**ENGINE FUEL AND CONTROL - LP/HP FUEL PUMPS - INTRODUCTION OF A REVISED LP/HP
FUEL PUMP WITH REDUCED GEARSHAFT BENDING**

V2500-ENG-73-0143

NO. 5008735-73-003

ENGINE - FUEL AND CONTROL - MODIFICATION OF LP/HP FUEL PUMPS IMPELLER/INDUCER AND CENTER PLATE

Modification of Impeller/Inducer
Figure 1

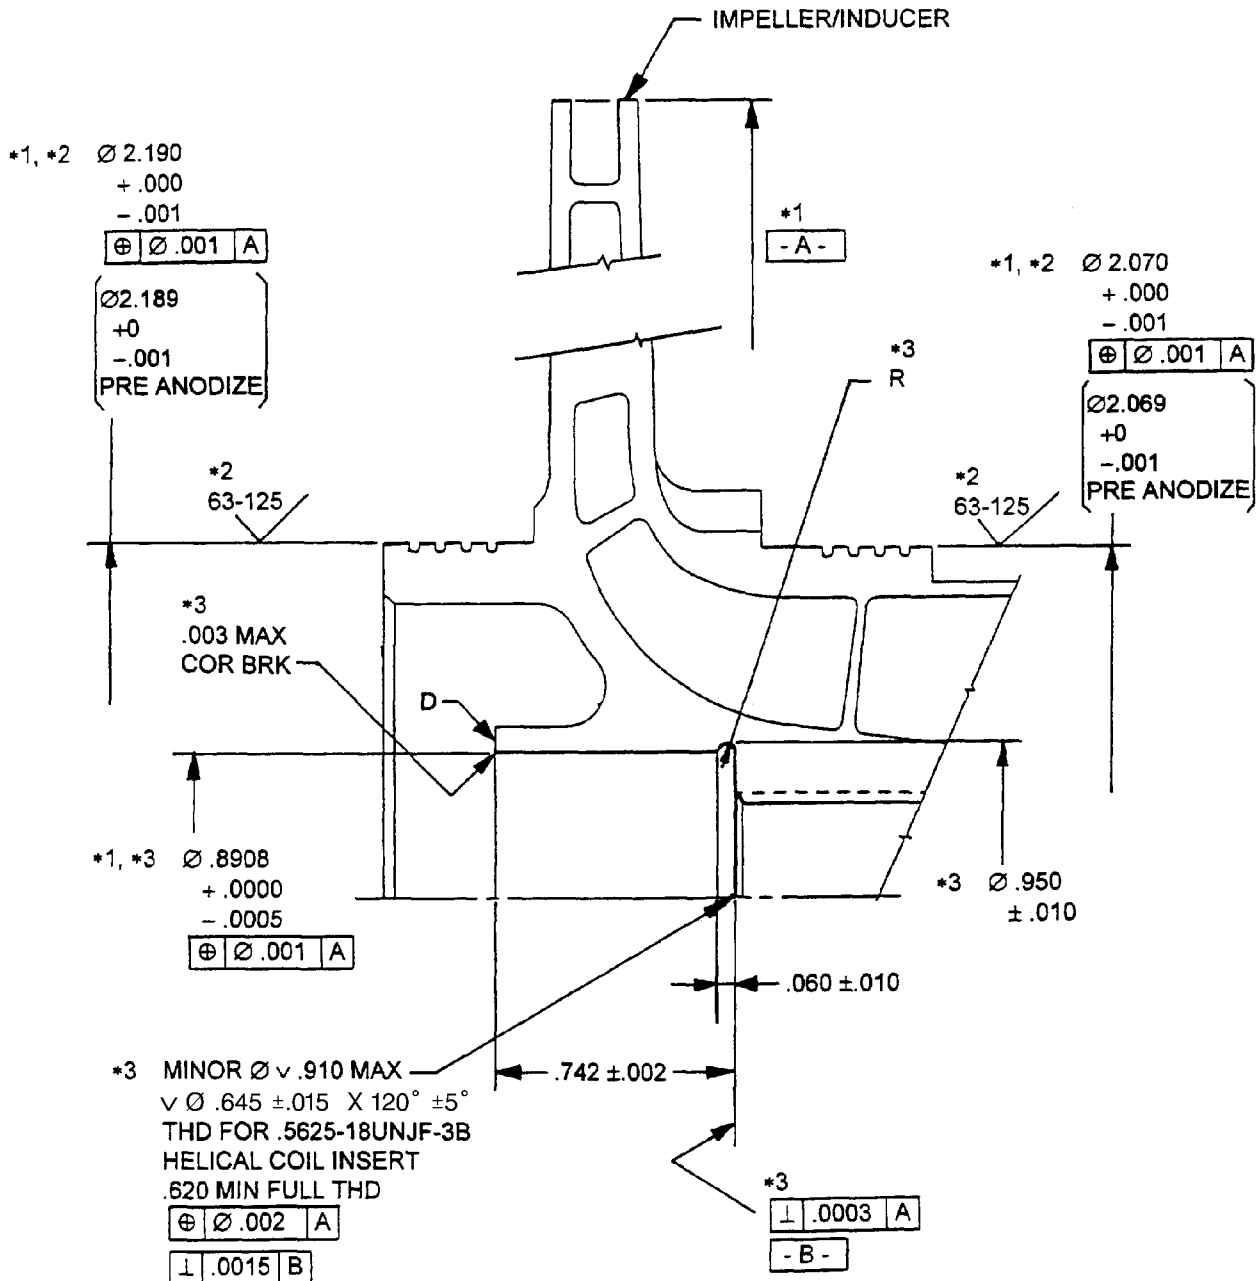
- A. Machine impeller/inducer and remove sleeve, spacer and helical coil insert if installed. (Refer to the Figure 2 of Modification of Impeller/Inducer.)
- B. Measure labyrinth surface finish. If it is more than 32 Ra, or if it is already worn and anodize has been removed, do not perform steps C. and F.
- C. Machine off anodized layer of two (2) labyrinth O.D. to diameter in Figure 2 to roughen it up to 63-125 Ra finish.
- D. Perform local fluorescent penetrant inspection according to Hamilton Sundstrand Standard Practices Manual, Bulletin 985, CHECK or Military Specification MIL-STD-6866.
- E. Apply chemical film to reworked surfaces per MIL-C-5541, TYPE 1A except two (2) labyrinth O.D.s (\varnothing 2.190, \varnothing 2.070) .

- F. Anodize two (2) labyrinth O.D.s (\varnothing 2.190, \varnothing 2.070) per MIL-A-8625, TYPE 3 (Refer to Figure 2) to build up .001/.002 inch diameter.
- G. Install helical coil insert (P/N MS124661) 1 to 1 1/2 pitches below the entering surface, and install spacer (P/N 767998).

NOTE: Helical diameter is now larger than Spacer I.D.

- H. Heat impeller/inducer and cool sleeve (P/N 767997) as required to obtain a temperature differential of at least 350 degrees Fahrenheit between the impeller and sleeve.
- I. Install sleeve to be flush/.005 inch below surface D. Allow impeller/inducer to cool to room temperature.
- J. Peen impeller/inducer on surface D of Figure 3 of Modification of Impeller/Inducer in four (4) places to retain sleeve.
- K. Finish machine sleeve installed in impeller/inducer according to Figure3.
- L. Clean according to Hamilton Sundstrand Standard Practices Manual, Bulletin 985, CLEANING or Cleaning instruction of the appropriate STS CMM in REFERENCE (1).

Modification of Impeller/Inducer
Figure 2

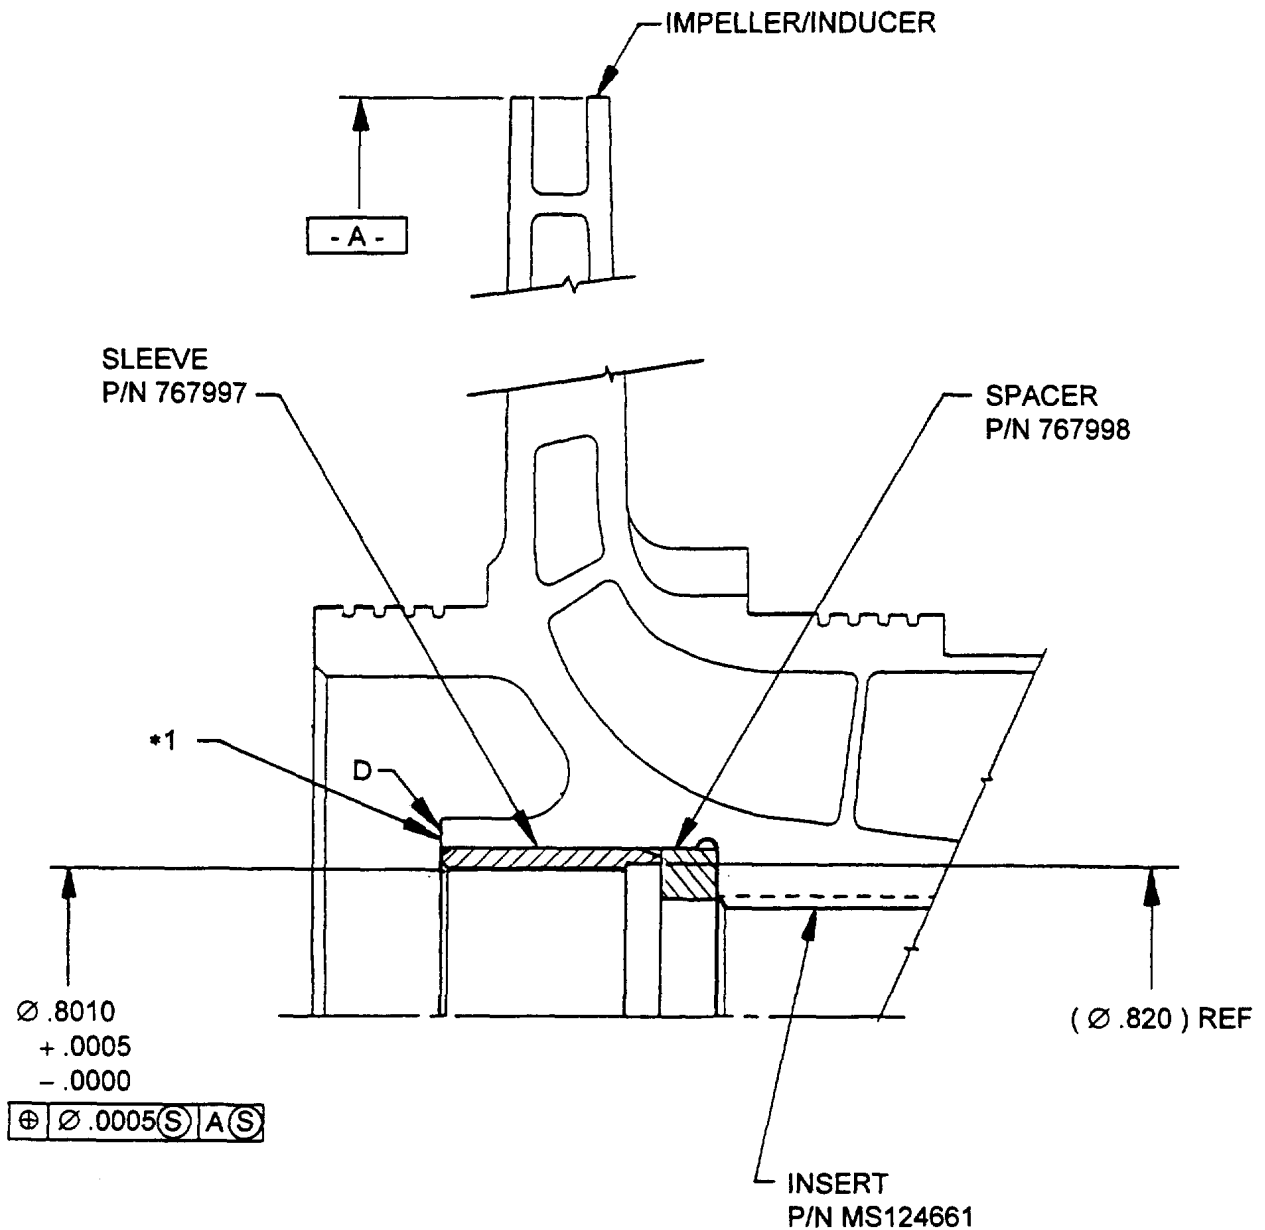
- NOTE**
- *1. ALIGN BEFORE MACHINING WITH INDICATED DIAMETERS.
 - *2. THESE DIMENSIONS ARE APPLIED AFTER ANODIZED PER MIL-A-8625, TYPE 3. DO NOT MACHINE AFTER ANODIZED.
 - *3. APPLY CHEMICAL FILM PER MIL-C-5541, CLASS 1A.

Modification of Center Plate Assembly
Figure 4

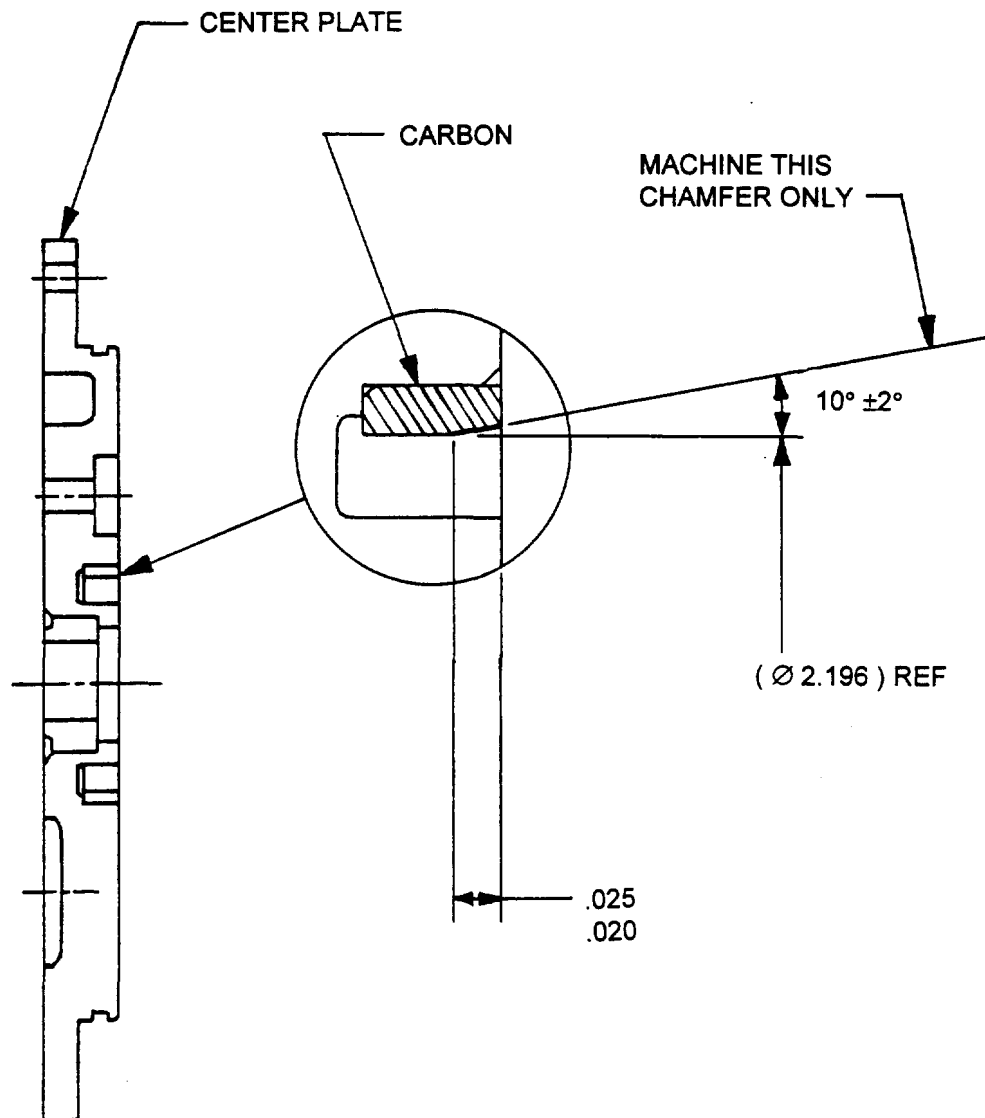
- A. Machine carbon ring in center plate. (Refer to the Figure 4 of Modification of Center Plate Assembly.)
- B. Clean according to Sundstrand Standard Practices Manual, Bulletin 985, **CLEANING** or Cleaning instruction of the appropriate STS CMM in **REFERENCE (1)**.

Inspection of Drive Gear and Impeller/Inducer
Figure 5

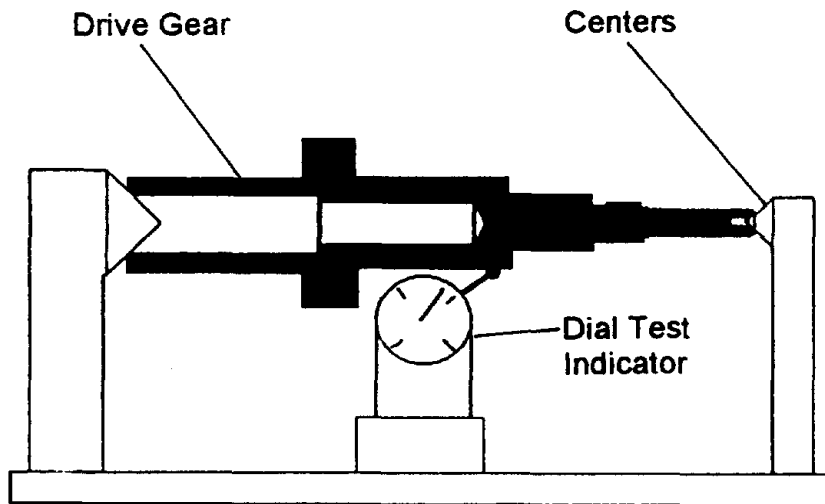
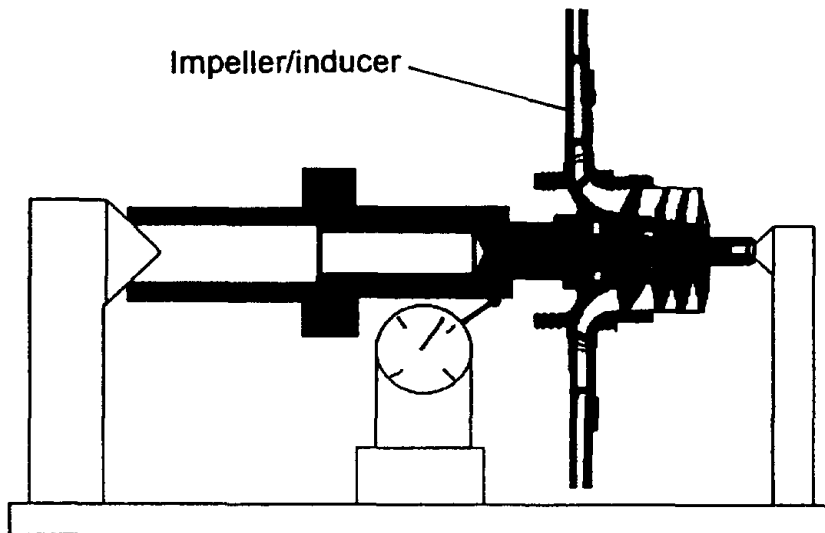
- (1) Assemble the drive gear on centers and measure the run-out of the journal nearest the impeller/inducer mounting thread, per Figure 5.
- (2) Attach the impeller/inducer to 170 in-lb torque above run-on torque and repeat (1).
- (3) If the run-out in step (2) is greater than step (1) by .0005 inch, replace the impeller/inducer and repeat the above.
- (4) If another impeller/inducer is not available, machine out the impeller sleeve ID to .8012 inch max. and repeat (1) to (3).
- (5) If the run-out is still bad, repeat (1) to (3) with a drive gear from another matched set. If the run-out is still bad, re-machine the impeller face and replace the washer. Repeat above. If the run-out is good with the different drive gear, then return the original gear set for investigation.

Drive Gear bending inspection
without LP Impeller/inducer installed

Drive Gear bending inspection
with LP Impeller/inducer installed

Modification of Impeller/Inducer
Figure 1

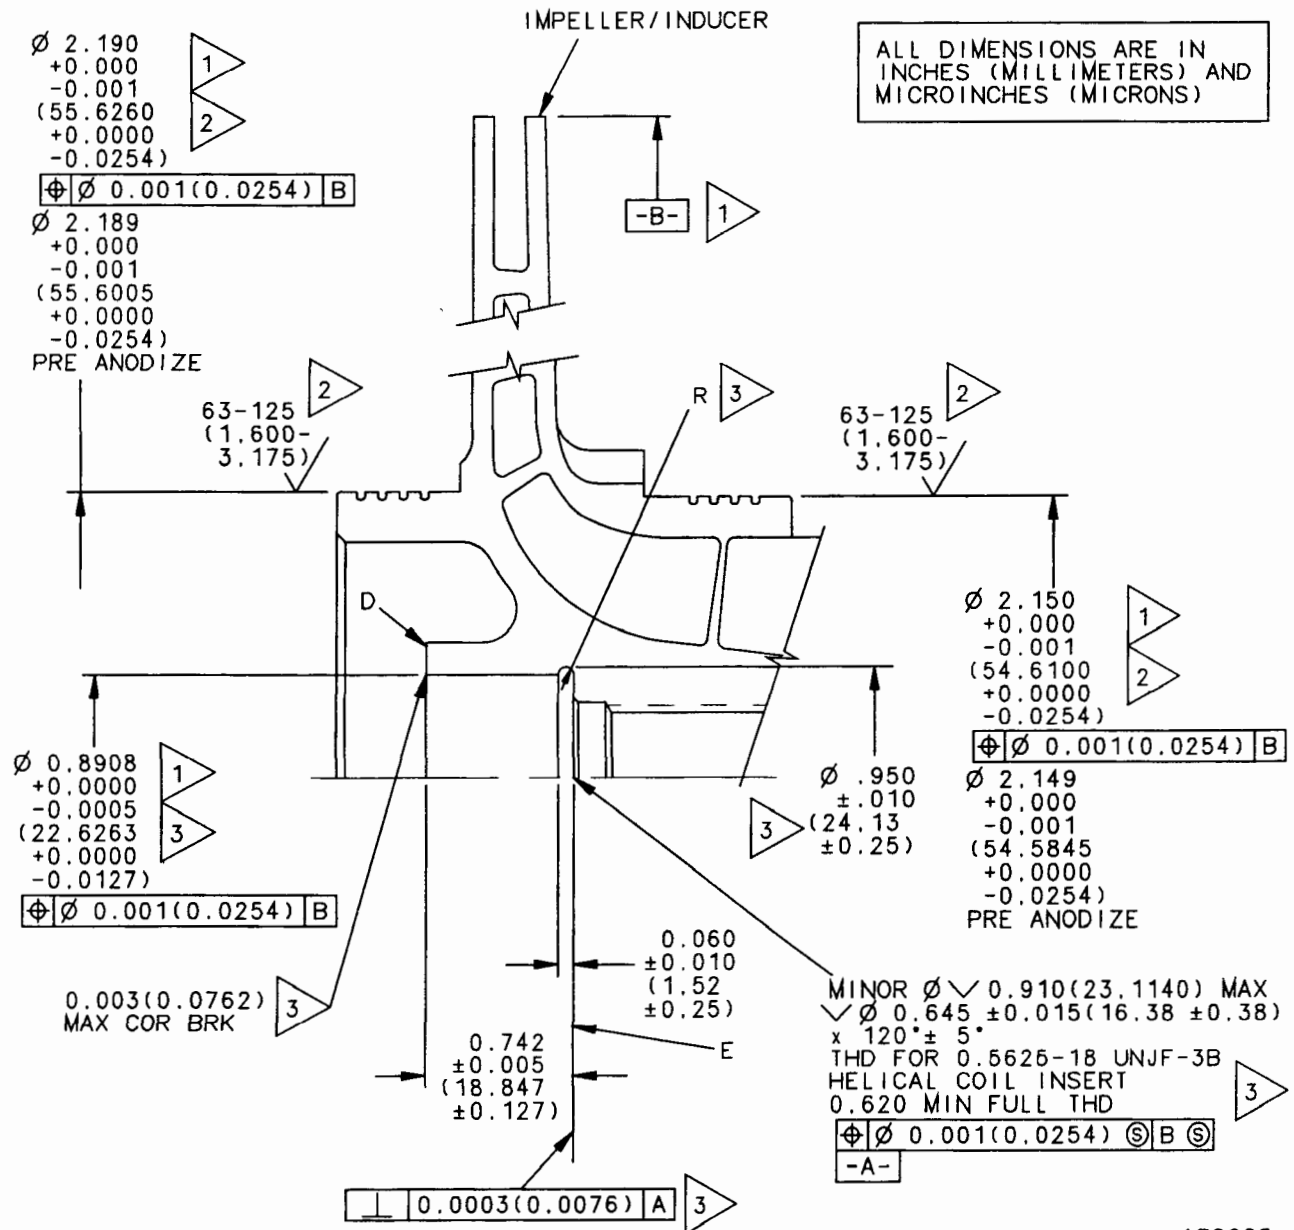
- A. If Service Bulletin STS-73-002 has been incorporated, machine the sleeve to a thickness of approximately 0.010-inch to allow removal. Remove spacer and helical coil insert. Run a tap through the thread several times to clean it up. The thread must be loose.

- J. Heat impeller/inducer and cool sleeve (P/N 767997) as required to obtain a temperature differential of at least 350 degrees Fahrenheit (177 degrees Celsius) between the impeller and sleeve.
- K. Install sleeve to be flush 0.000 to 0.005 inch (0.000 to 0.1270 millimeter) below surface D of Figure 3 of this service bulletin. Allow impeller/inducer to cool to room temperature.
- L. Peen impeller/inducer on surface D of Figure 3 of this service bulletin in four places to retain sleeve.
- M. Finish machine sleeve installed in impeller/inducer according to Figure 3 of this service bulletin.
- N. Clean according to SPM Bulletin 985, CLEANING or CMM 73-18-41, CLEANING.

Modification of Impeller/Inducer Figure 2

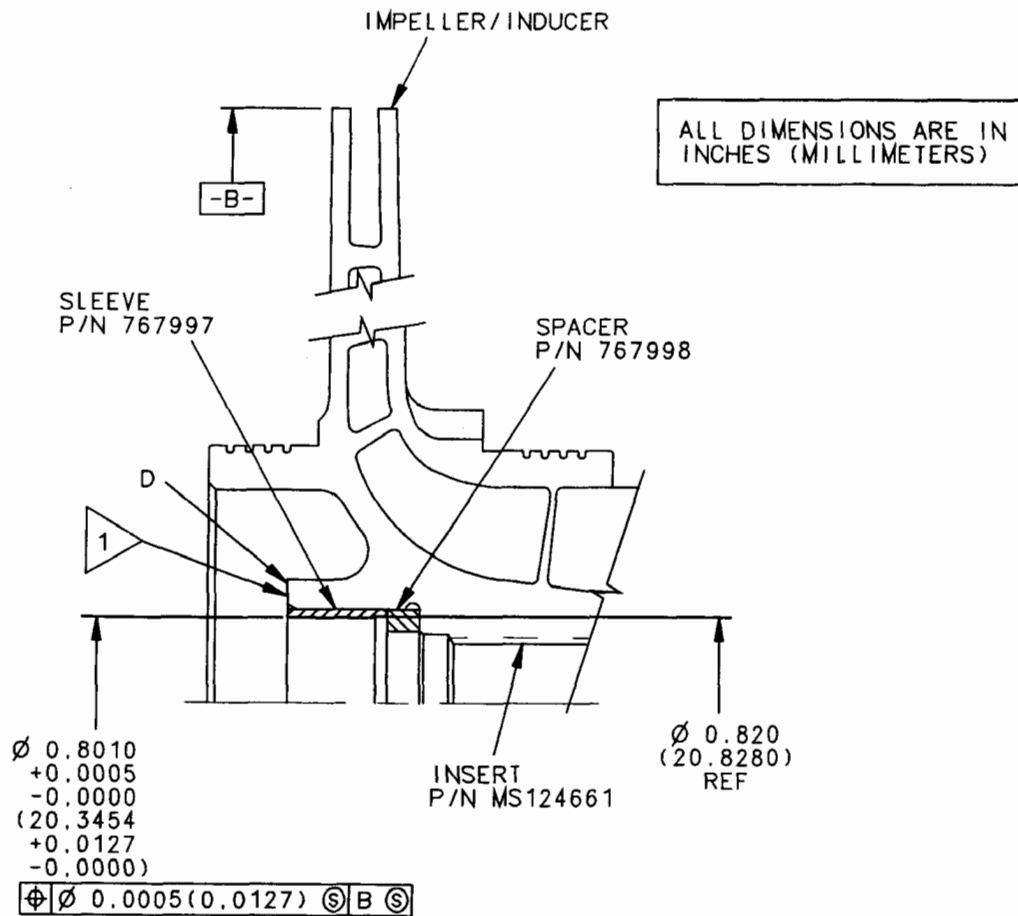
- B. Machine the impeller inducer (refer to Figure 2 of this bulletin).
- C. Visually check labyrinth surface finish. If it is more than 32 micro inch (0.813 micrometer) Ra, or if it is already worn and anodize has been removed, do not perform steps C. and F.

- D. Machine off anodized layer of two labyrinth outside diameters to diameters in Figure 2 of this service bulletin to roughen it up to 63-125 micro inch (1.600 to 3.175 micrometer) Ra finish.

- G. Anodize two labyrinth outside diameters according to MIL-A-8625, TYPE 3 (Refer to Figure 2 of this service bulletin) to build up 0.001 to 0.002 inch (0.026 to 0.050 millimeter) diameter.
- H. Install helical coil insert (P/N MS124661) 1 to 1-1/2 pitches below the entering surface, taking care not to damage the entering surface, and install spacer (P/N 767998).

- I. Perform inspection for run-out [refer to paragraphs 2.C.(1) through 2.C.(3) of this bulletin]. Remachine surface E of Figure 2 until run-out is satisfactory.

- 1 Align before machining with indicated diameters.
- 2 Noted dimensions applied after anodized per MIL-A-8625, Type 3. Do not machine after anodized.
- 3 Apply chemical film per MIL-C-5541, Class 1A.

Modification of Center Plate Assembly
Figure 4

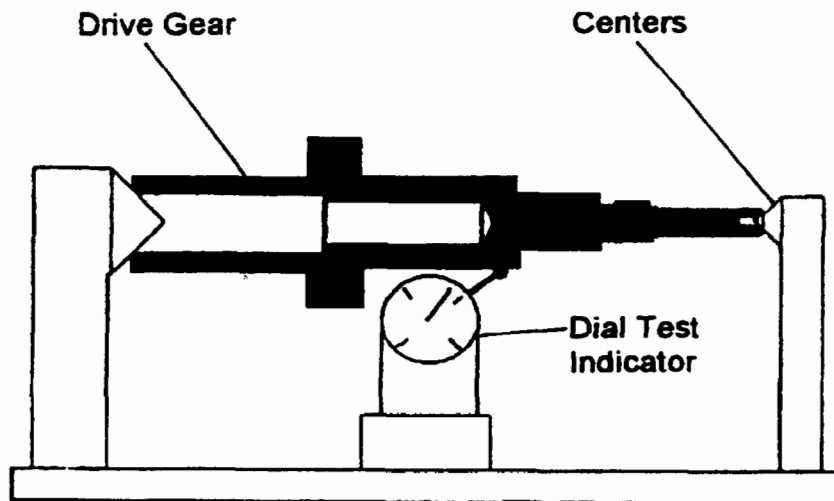
- A. Machine carbon ring in center plate. (Refer to Figure 4 of this service bulletin).
- B. Clean according to SPM Bulletin 985, CLEANING, or cleaning instruction of CMM 73-18-41.

**Inspection of Drive Gear and Impeller/Inducer
Figure 5**

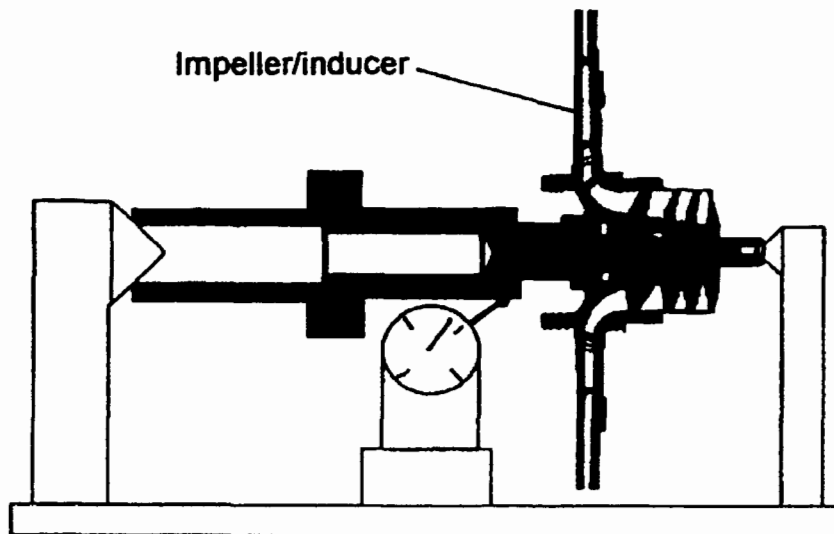
- (1) Assemble the drive gear on centers and measure the run-out of the journal nearest the impeller/inducer mounting thread according to Figure 5 of this service bulletin.

- (2) Attach the impeller/inducer to 170 pound-inches (19.3 Newton meters) torque above run-on torque and repeat step (1).
- (3) If the run-out in step (2) is greater than step (1) by 0.0007 inch (0.0178 millimeter), replace the impeller/inducer and repeat the above.

- (5) If the run-out is still bad, repeat steps (1) to (3) with a drive gear from another matched set or another impeller. If the run-out is consistently bad, remove sleeve and washer and remachine bore and shoulder concentric and perpendicular to the thread. Repeat above. If the run-out is satisfactory with the different drive gear, then return the original gear set to Hamilton Sundstrand for investigation.
